MIL-M-28787/114A
AMENDMENT 3
31 December 1992
SUPERSEDING
AMENDMENT 2
4 June 1984

*MODULES, STANDARD ELECTRONIC

GATE, NAND, DIGITAL, KEY CODE BDA

FIGURE 2. Operating temperature and life test circuit.

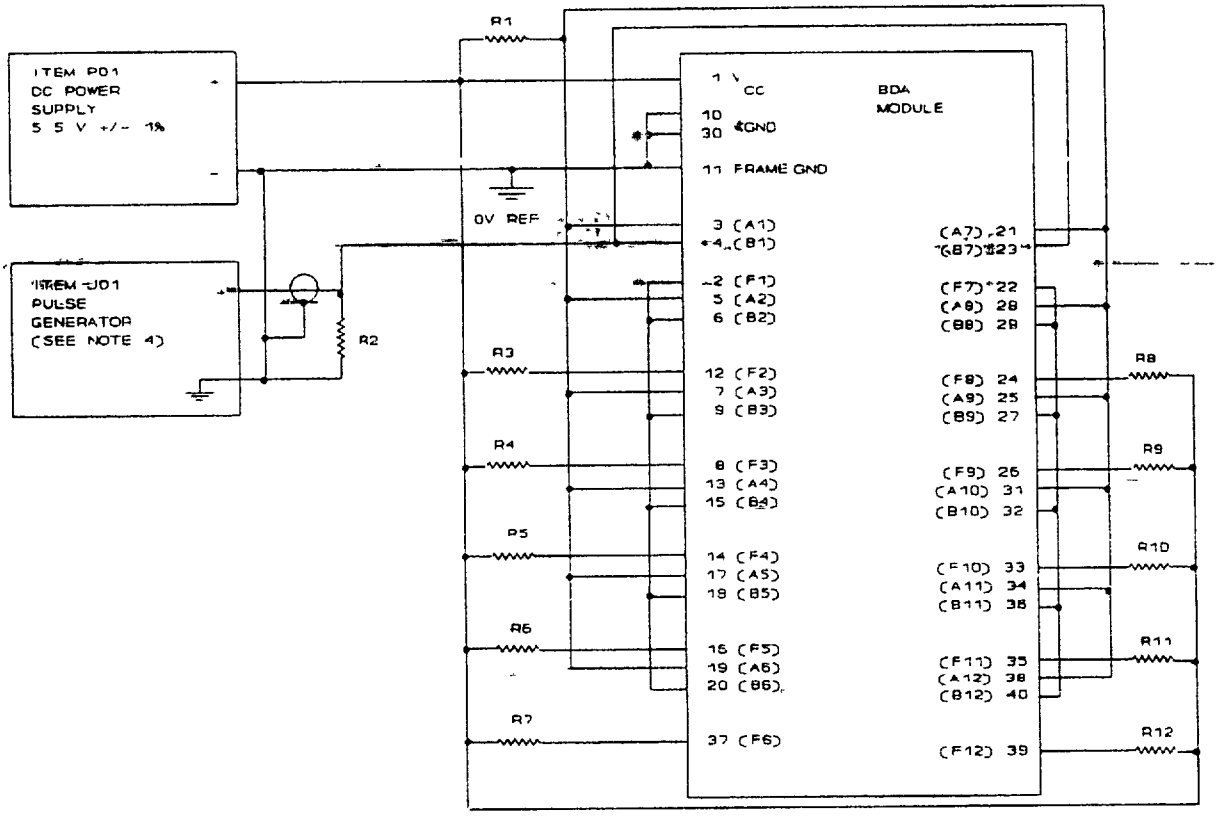
FIGURE 2: Delete and substitute new figure 2 as printed on page 3 of this amendment.

1. R1 = 1 kΩ ± 1%, 1/8W.
2. R2 = 50Ω ± 5%, 1/2W.
3. R3-R12 = 422Ω ± 1%, 1/8W.
4. Input pulse parameters: Pulse width (PW) = 500 ± 50 ns.
   PRP = 1,000 ± 100 ns.
   Pulse amplitude = 3.0 ± 0.1V.
   $t_{TLH} = t_{THL} = 20 \pm 2$ ns.

FIGURE 5. Zener applied potential test circuit for table III.

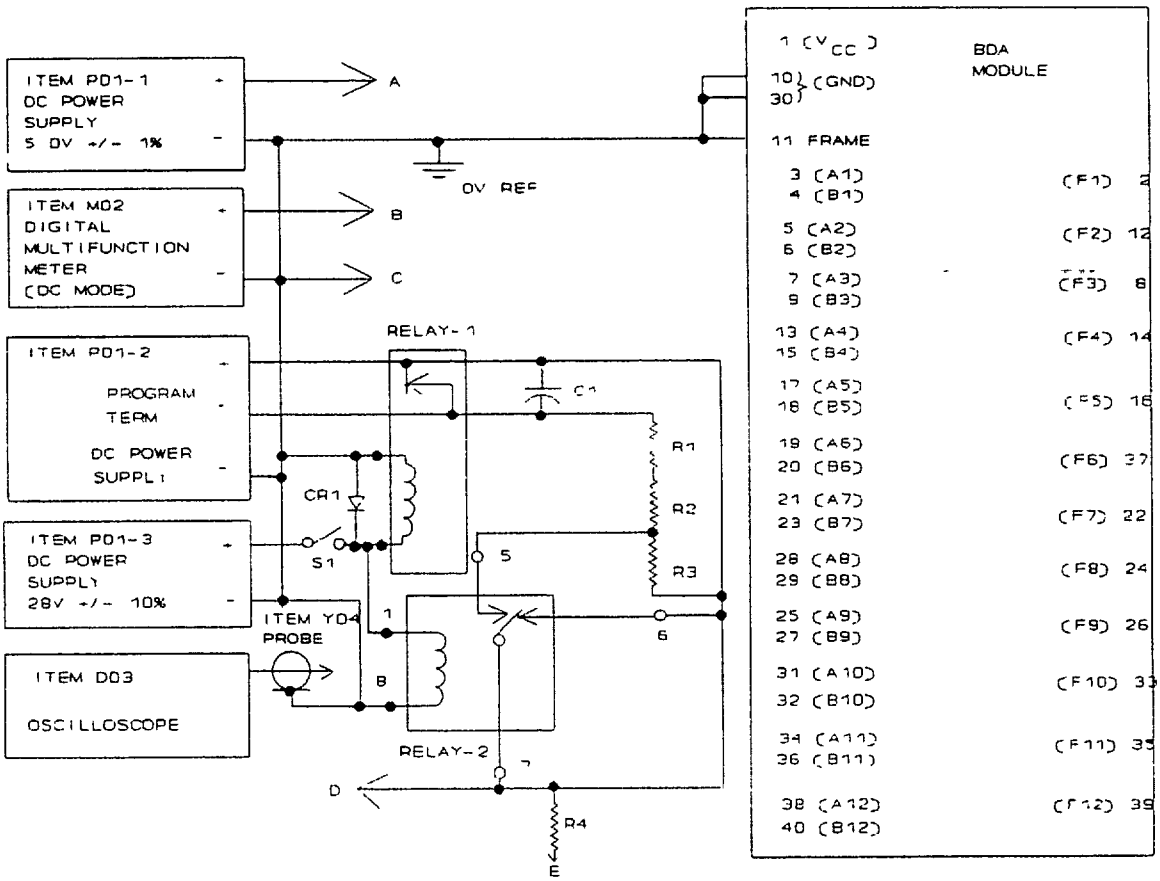
FIGURE 5: Delete and substitute new figure 5 as printed on page 4 of this amendment.

FIGURE 6. V_{OUT} (low loaded) test circuit for table IV.

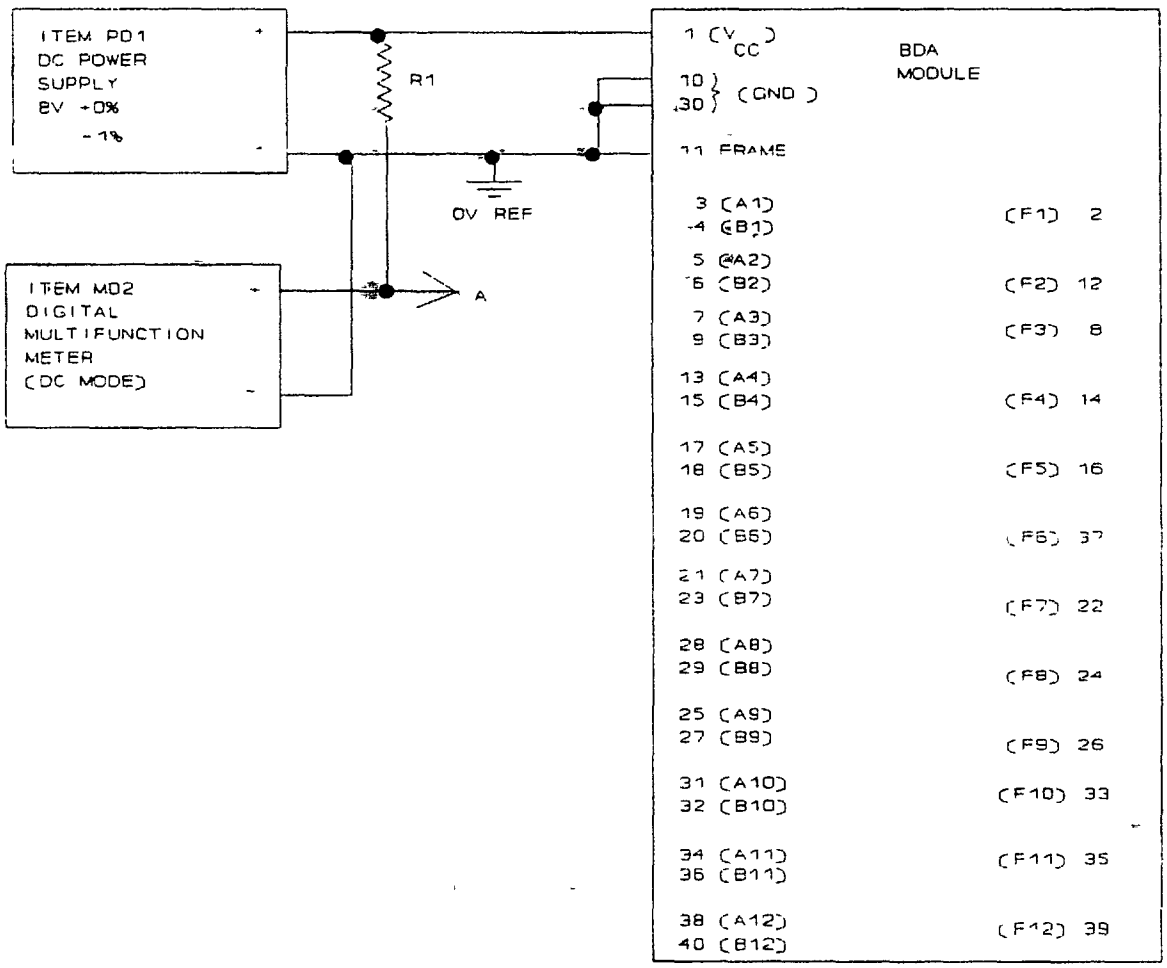
FIGURE 6: Delete and substitute new figure 6 as printed on page 5 of this amendment.

1. R1 = 261Ω ± 1%, 1/2W.
2. After point A has been connected to the appropriate module pin, the output shall be monitored for a minimum of 10 seconds before taking the measurement.

FIGURE 8. Output voltage (high-level and low-level) test circuit for table VI

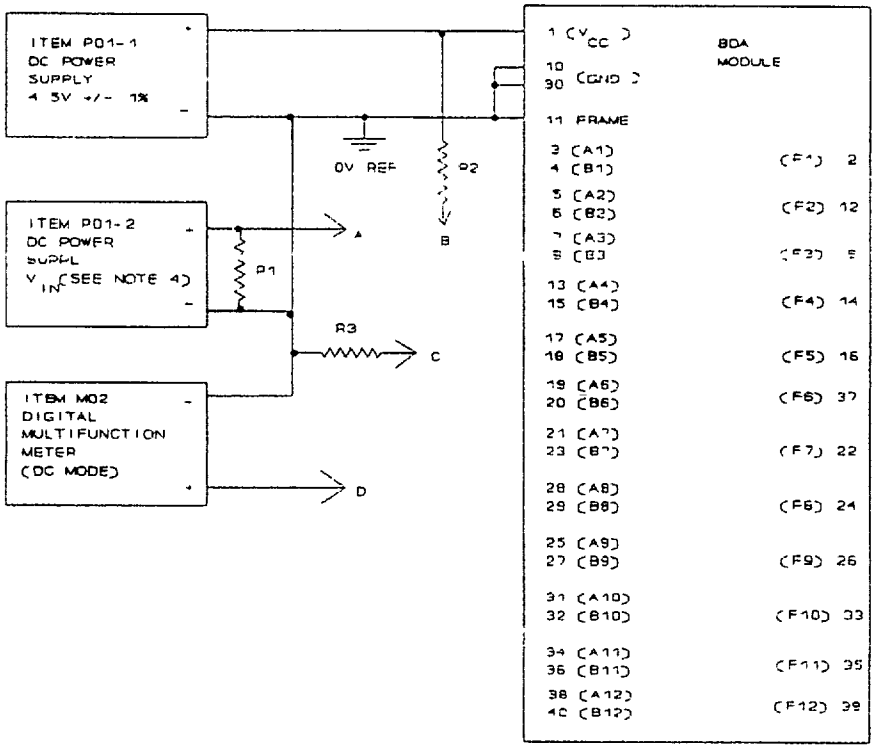
FIGURE 8: Delete and substitute new figure 8 as printed on page 6 of this amendment.

1. R1 = 127Ω ± 1%, 1/8W.
2. R2 = 348Ω ± 1%, 1/8W.
3. R3 = 61.9Ω ± 1%, 1/8W.
4. Use appropriate V_{IN} for specified test condition and temperature listed below:

Test cond	Temperature (°C)	VIN (volts)
E1-E24	0	1.20
	25	1.10
	60	0.95
	80	0.80
F1-F12	0	2.0
	25	1.9
	60	1.8
	80	1.8

0°, 60°, and 80°C refer to operating temperatures (module fin); 25°C refers to ambient temperature. For 80°C use the 0° to 60°C end-of-life limits
